EPA Response to Comments

**EPA Region 8**  
**Underground Injection Control (UIC) Program**  
**Response to Public Comments**

**Class III Area Permit No. SD31231-00000, Aquifer Exemption Decision**  
**And**  
**Class V Area Permit No. SD52173-00000**

**Powertech (USA) Inc.**  
P.O. Box 448  
Edgemont, South Dakota 57735

**Figure A. Gott et al., 1974, Plate 2 showing the extent of the Dewey Fault and Structural Zone with the Dewey-Burdock Project Area superimposed.**

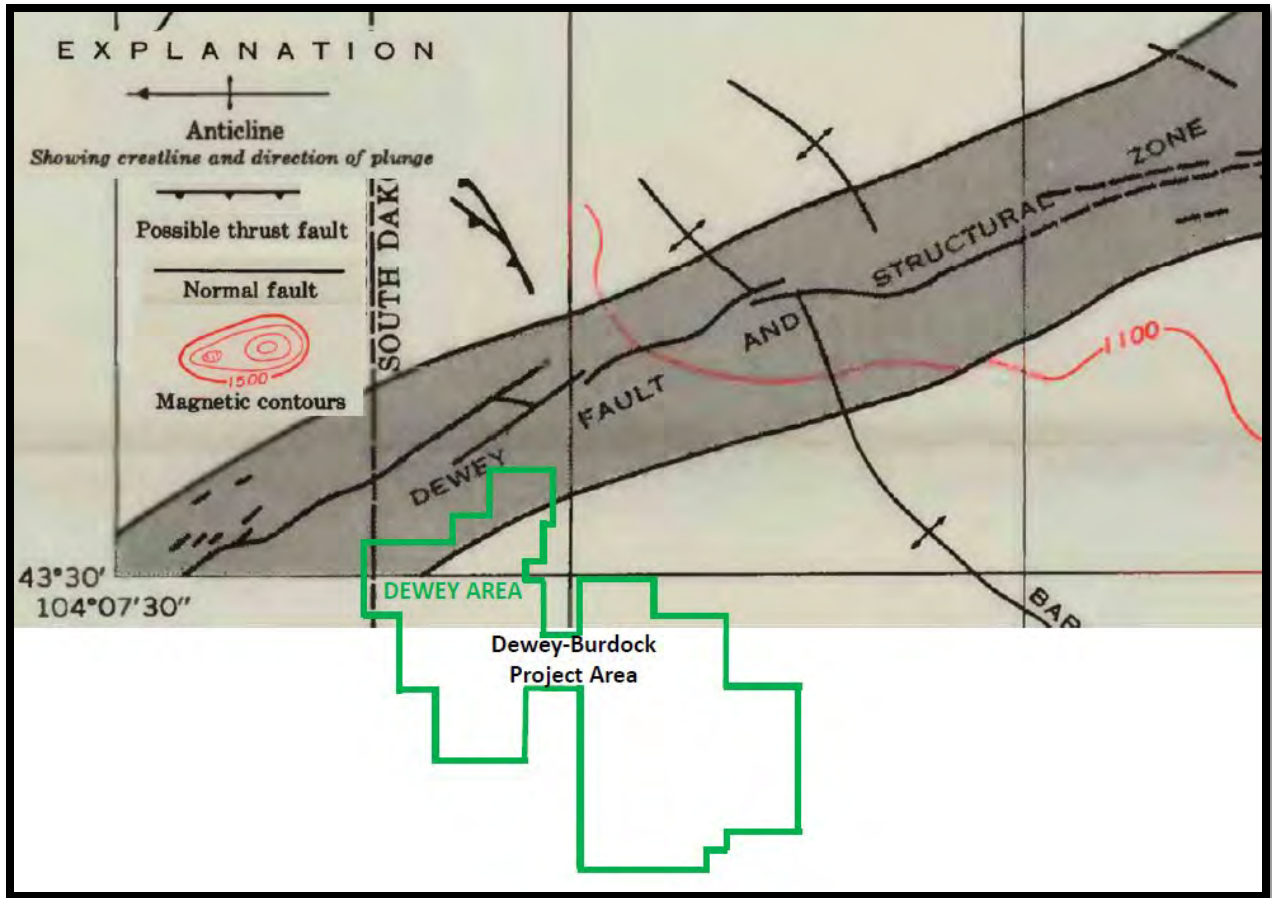
There is no evidence of the Dewey fault inside the project area. (Brobst, 1961, *Geology of the Dewey Quadrangle Wyoming-South Dakota*, USGS Bulletin 1063-B.) Brobst, 1961, describes the Dewey Fault in the Dewey quadrangle geologic report as the fault passing through the town of Dewey and refers to the fault located to the southeast without a name. Braddock, 1963, does not refer to more than one fault plane related to the Dewey Fault in the Geology of the Jewel Cave SW quadrangle report (Braddock, W.A., 1963, *Geology of the Jewel Cave SW quadrangle Custer County, South Dakota*, USGS Bull 1063-G). Gott, et al., 1974, includes both faults described by Brobst, 1961, in the Dewey Fault and Structural Zone. The boundaries of this structural zone are shown in Plates 2 and 4 of the Gott et al., 1974 report. The extent of the Dewey Fault and Structural Zone as defined by Gott in Plate 2 near the Dewey-Burdock Project Site is shown in Figure A. The Dewey-Burdock Project Site Boundary is superimposed on Plate 2. Although Gott shows the Dewey Fault and Structural Zone as extending into the northwestern edge of the Dewey-Burdock Project Site, there is no evidence of any fault inside the Project Area.

**Figure B. Excerpt from Gott et al., 2001, Plate 4 showing features inside the Dewey-Burdock Project Boundary.**

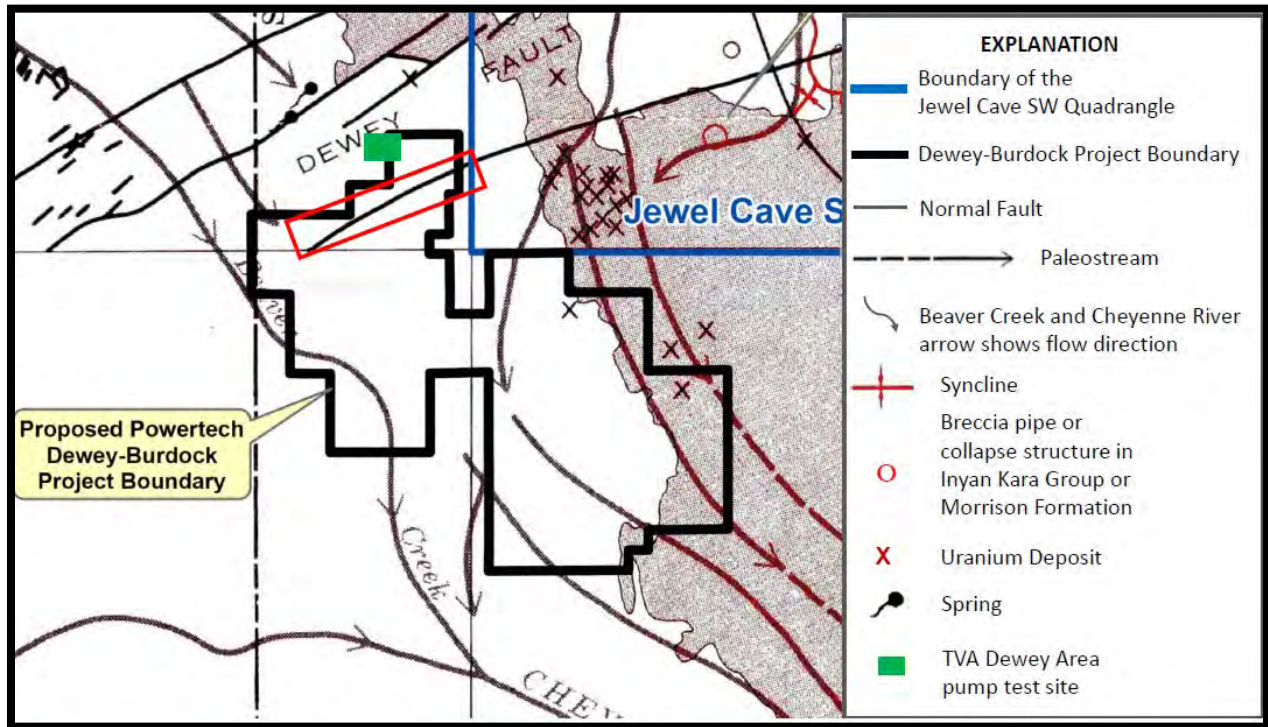
A commenter referred to Plate 4 from Gott et al., 1974, as the Gott fault map. Powertech used Plate 4 as a base map for Plate 6.24 of the Class III Permit Application and superimposed the Dewey-Burdock Project Boundary to show where the collapse features and breccia pipes identified in Gott et al., 1974, are located relative to the Project Site. Plate 6.24 shows that none of these features are located inside the Project Area. Figure B is an excerpt from Plate 6.24. The features shown inside the project boundary are Beaver Creek and paleostreams. The linear feature in the red box inside the Dewey-Burdock Project Area is the southeast boundary of the Dewey-Fault and Structural Zone shown in Plate 2.

EPA disagrees with the commenter's statement that the features in Plate 4 demonstrate that EPA failed to conduct the necessary physical surveys to confirm or deny the presence of these geological features. Based on the discussion above regarding the features identified in Plate 4 within the Project Area, there is no need for EPA to perform a physical survey because no disruption of confining zones in the currently proposed wellfield areas is indicated by the information in Plate 4.

**Figure C. Dewey wellfield locations relative to the possible normal fault location in the Dewey-Burdock Project Boundary.**

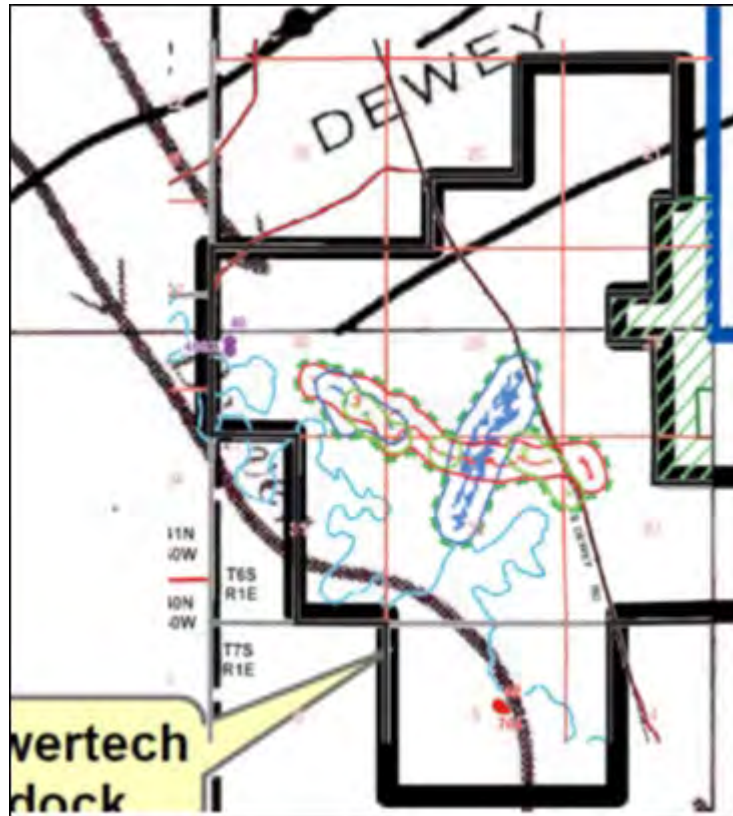
Figure C shows that the southeastern edge of the Dewey Fault and Structural Zone does not intersect the proposed wellfields in the Dewey Area, so it is not of concern for the currently proposed for ISR operations. The fact that the Dewey Fault and Structural Zone is located upgradient of the Dewey wellfields and the inward hydraulic gradient required for each wellfield will prevent ISR injection interval fluids from migrating to the location of this zone. If Powertech proposes future wellfields in this area, correlation of drillhole data in the area would identify any offset of geologic strata caused by the presence of a fault.

**Figure D. Potentiometric surface contour maps of the Fall River and Chilson aquifer from Figures 5.2 and 5.3 of the Class III Permit Application.**

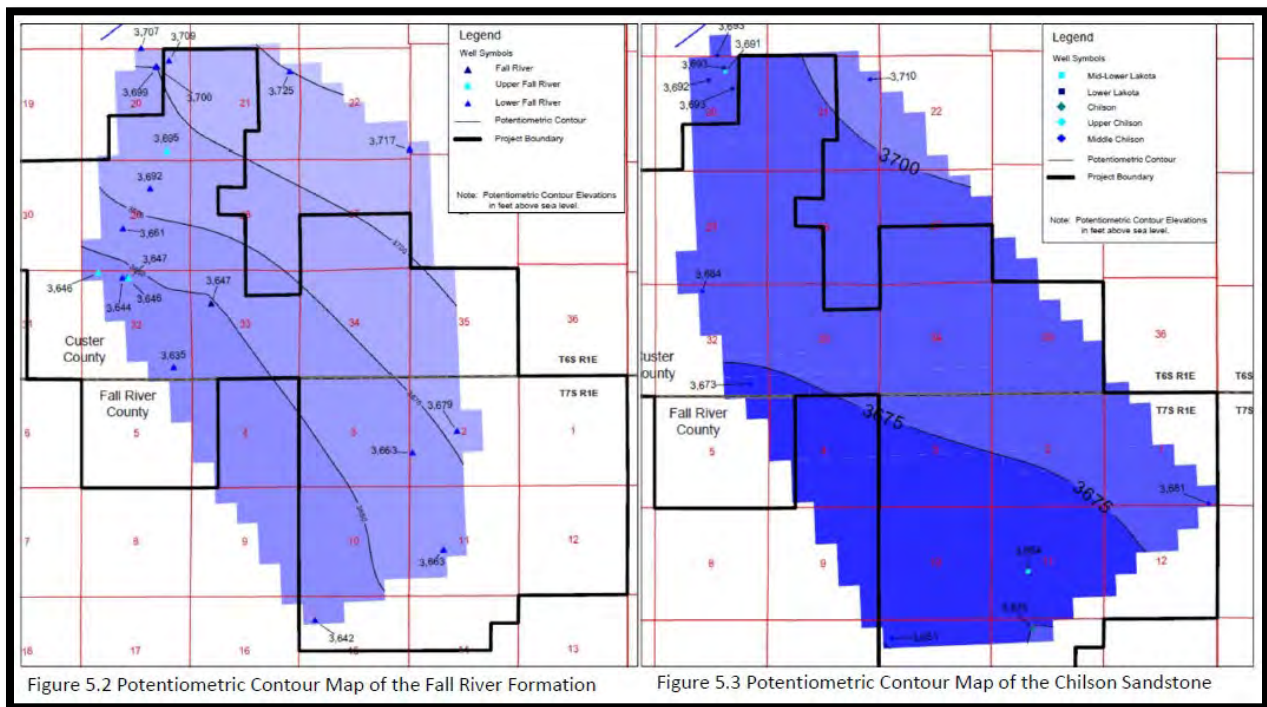
EPA disagrees with the interpretation that the potentiometric surface of the Fall River aquifer and the Chilson aquifer being at similar elevations in the vicinity of wellfields 6, 7 and 8 indicates leakage through the Fuson confining zone in this area. Figure D shows the potentiometric surface contours of the Fall River and Chilson aquifer based on water level measurements in wells completed in each aquifer.

These maps show that the potentiometric surface of the Fall River aquifer is at a higher elevation than that of the Chilson in the northeastern portion of the project area. The Chilson aquifer potentiometric surface is at a higher elevation than that of the Fall River aquifer in the southwestern portion of the project area. At some point these potentiometric surface elevations are at the same elevation, as demonstrated by the cross-sections shown in Plates 6.13 and 6.14 of the Class III Permit Application. EPA concludes that this is the reason for the similarity in elevation of the Fall River and Chilson potentiometric surfaces in the vicinity of Burdock Wellfields 6, 7 and 8.

Figure E. Areas of the Inyan Kara Group aquifers approved by this Record of Decision.

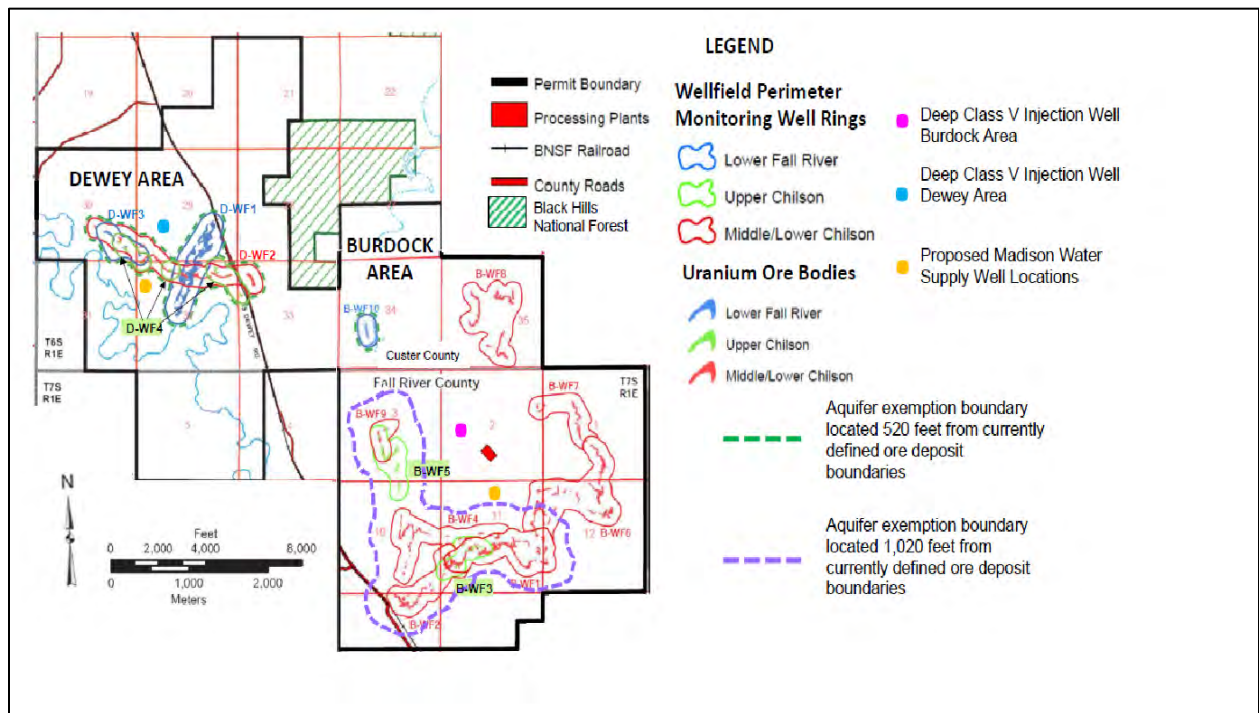
Powertech requested an expanded AE area to accommodate additional ore resources identified after the Class III Permit Application was submitted. EPA reviewed the Preliminary Economic Assessment reports developed by consultants documenting independent audits of mineral resource estimates at the Dewey-Burdock Project Site and determined that the commercially producible ore resource boundary had expanded in Burdock Wellfields 1 through 5, 9 and 10 since Powertech submitted the Class III Permit Application, justifying expanding the AE boundary for these wellfields. However, the commercially producible ore resource boundaries had not expanded for the other wellfields, so EPA did not expand the AE boundaries for these other wellfields. Because Powertech needs to do additional work to demonstrate that the potentiometric surfaces in Burdock Wellfields 6, 7 and 8 are able to sustain adequate monitoring of ISR operations in the overlying Upper Chilson aquifer, EPA is postponing approval the aquifer exemption in the area of Burdock Wellfields 6, 7 and 8 until Powertech performs further aquifer testing in that area.

Figure F. Minnelusa aquifer groundwater flow direction map from Figure 17, Driscoll et al., 2002.

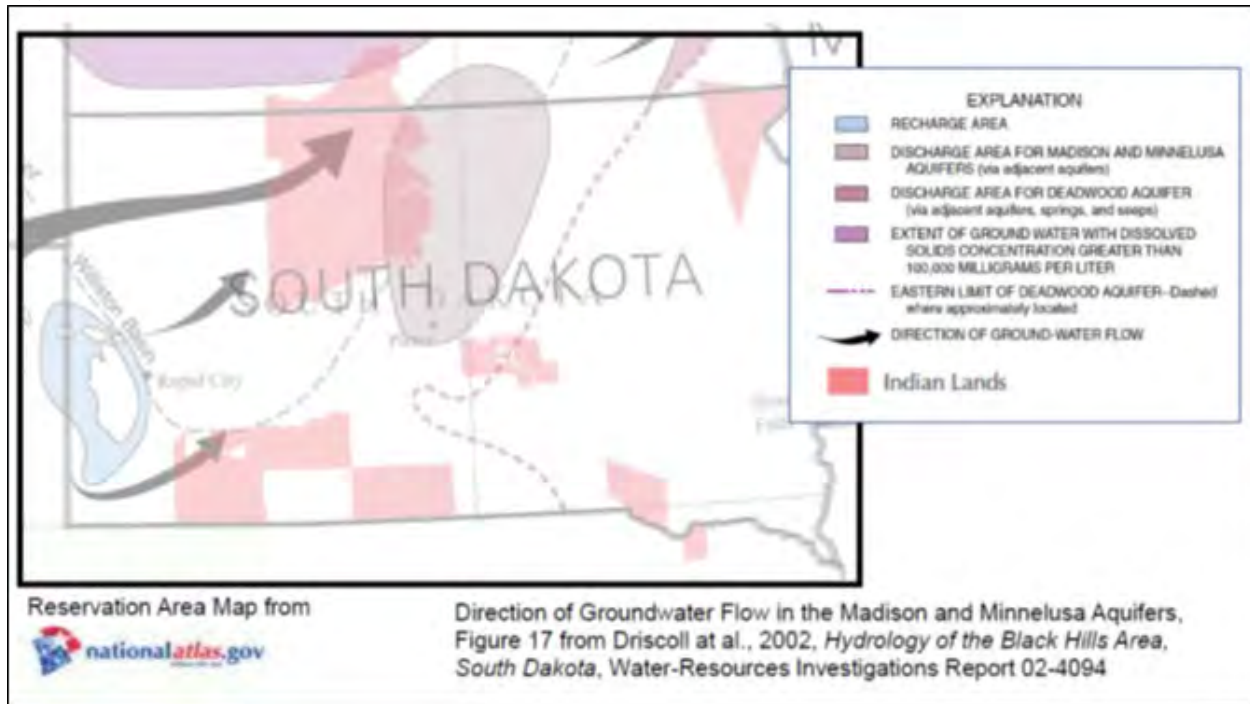
EPA investigated groundwater flow directions in the Minnelusa aquifer at the Dewey-Burdock Project Site and at the springs, such as Cascade Springs, south of the Black Hills. Figure F is a groundwater flow direction map from Figure 17 in Driscoll et al., 2002. This map shows the direction of groundwater flow in the Minnelusa aquifer from its recharge area in the Black Hills to a discharge area located at the eastern edge of the Cheyenne River Reservation. As shown in the map in Figure F, the authors hypothesize that the Minnelusa aquifer groundwater flows from the Dewey-Burdock site and flows around the southern end of the Black Hills toward the Williston Basin. (Driscoll, D.G., et al., 2002, *Hydrology of the Black Hills Area, South Dakota*, USGS Water-Resources Investigations Report 02-4094 at 22)

**Figure G. Minnelusa aquifer potentiometric surface elevation contours in the area where springs occur south of the Black Hills (from Sheet 2, Strobel et al., 2000)**

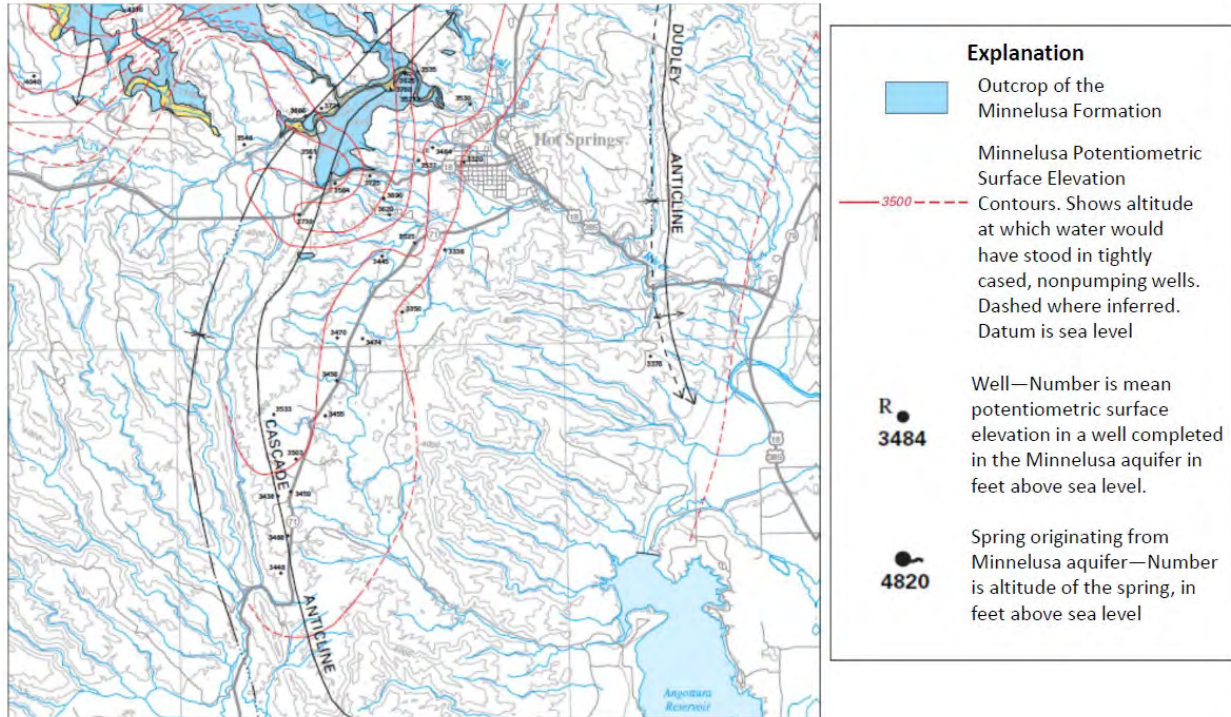
Figure G is the area where springs, including Cascade Springs, are located south of the Black Hills, excerpted from Sheet 2 of Strobel et al., 2000. The red lines show the potentiometric surface elevations based on wells completed in the Minnelusa and springs flowing from the Minnelusa. The potentiometric surface contours are deflected southward along the Cascade anticline where the Minnelusa and other geologic strata are raised in elevation. (Strobel et al., 2000)

Figure H. Elevation of the Minnelusa Formation top surface (Source: Sheet 2 of Carter and Redden, 1999)

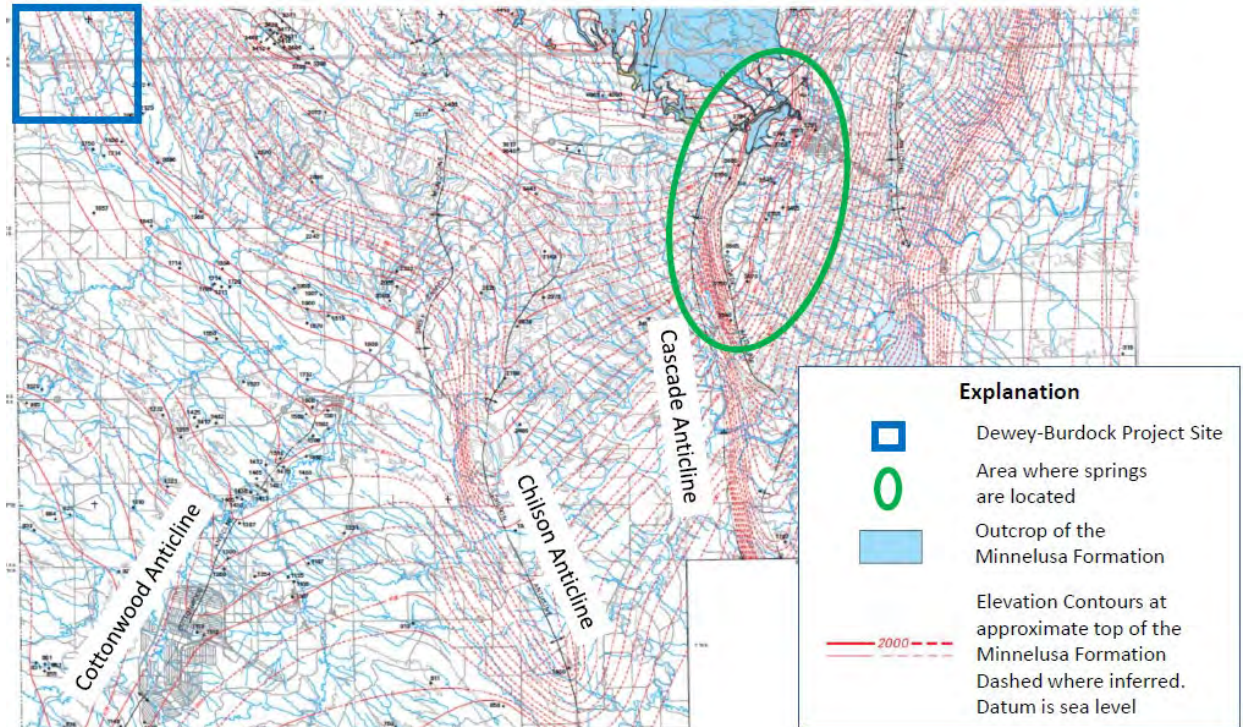
Figure H shows the area south of the Black Hills, excerpted from Sheet 2 of Carter and Redden, 1999. (Carter, J.M. and Redden, J.A., 1999, *Altitude of the Top of the Minnelusa Formation in the Black Hills Area, South Dakota*, USGS Hydrologic Investigations Atlas HA-744-C, Sheet 2) In this figure the red lines are elevation contours along the top of the Minnelusa Formation. The springs shown in Figure G are located inside the green oval. Based on the elevation of the top of the Minnelusa Formation shown in the area where springs occur south of the Black Hills, the top of the Minnelusa Formation is at a higher elevation at this location than at the Dewey-Burdock Project Site. Figure H shows how the Cottonwood, Chilson and Cascade anticlines affect the Minnelusa Formation elevation. The Class V injectate from the Dewey-Burdock site would have to flow uphill to reach the location of these springs. Based on the potentiometric surface contours in Figure G, the flow path of Class V injectate would be deflected to the south by the Chilson and Cascade anticlines and would have to flow uphill to reach these springs where Minnelusa and Madison groundwater flows to the surface.

Figure I. Locations of springs emanating from or passing through the Minnelusa aquifer, from Figure 29 of Naus et al., 2001.

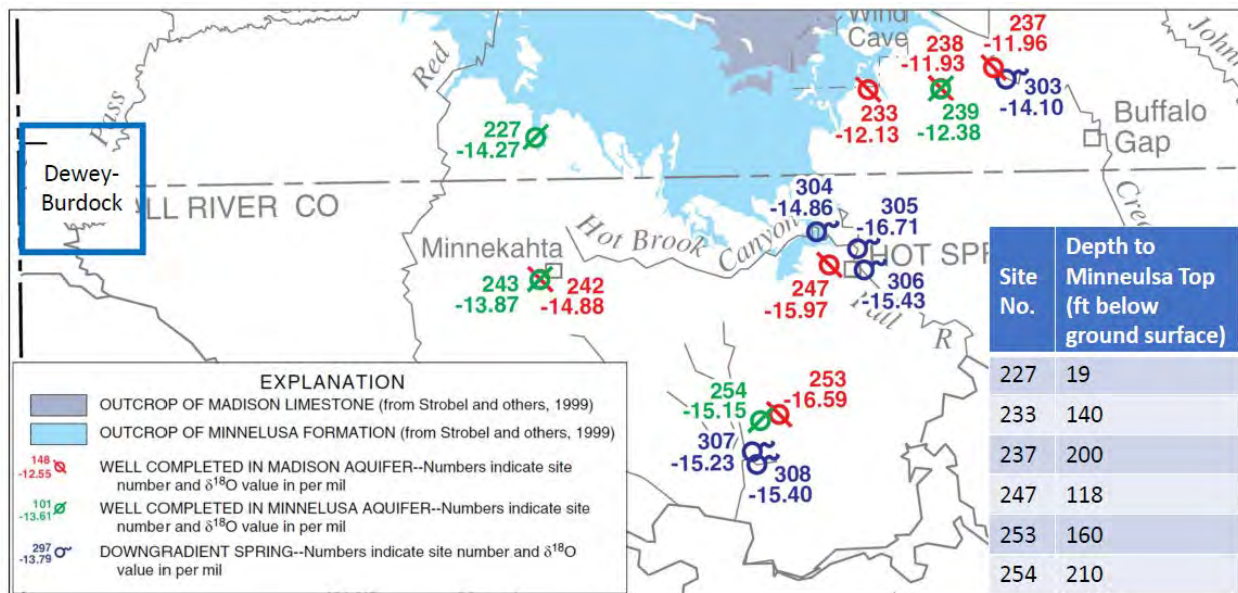
EPA reviewed water well logs in the area near the springs flowing from the Minnelusa and Madison aquifers. Figure I shows locations of Minnelusa (green) and Madison (red) wells and springs. The blue table in Figure I shows the depth to the top of the Minnelusa Formation in the logs for wells shown in Figure H. The springs occur where the top of the Minnelusa aquifer occurs closer to the ground surface. For example, at the location of the springs shown in Figure H the top of the Minnelusa is approximately 200 feet or less below ground surface, based on nearby private well logs.

Based on this analysis, EPA concludes that the Class V injectate will not contaminate the Madison aquifer and will not reach the area where the artesian springs are located.
